## Hello All,

## **Updated Map:**

## Clarification on Process:

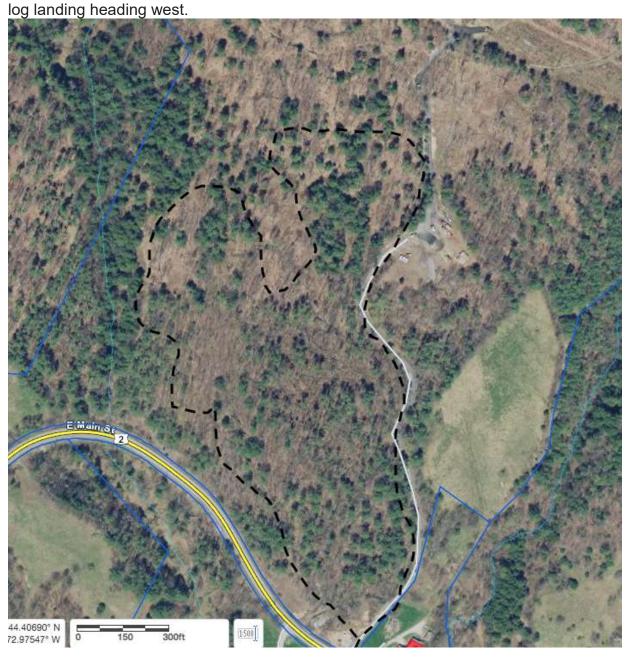
Please understand that this is mapped with GPS points and then I drew in the trail using those coordinates. The black dotted line is the proposed trail and you will see that the trail uses the dirt road up to the log landing and then goes into the woods just after the

We did have to modify the trail from the original design by Arrowhead (SE Group) on the lower section of the trail that is west of dirt access road. The original trail concept map was flagged due to contour lines and had not been previously walked and when we walked the proposed trail realized it was too wet for trail construction.
